Canon F-1

CANON SERVICE MANUAL

Canon SERVICE MANUAL REPORT

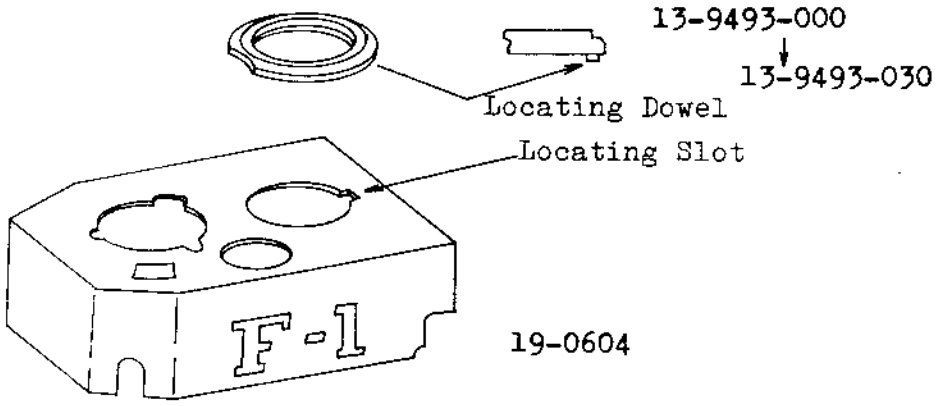
When Shutter Index Ring(13-9493) became a separate part (AC30-071), the locating dowels were used on the Top Cover (19-0604). Now a locating dowel is moulded into the ring and a slot is cut in the top cover. (Repair Manual , pg. 1 and Service Manual Report AC30-071)

1.2. Mirror Charge Lever

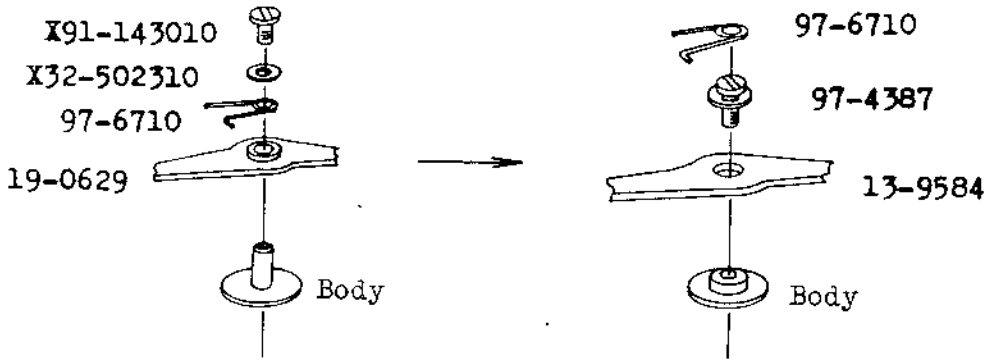
The riveted bush has been eliminated from Mirror Charge Lever(19-0629) , the body bearing stud and retaining screw have also been redesigned.
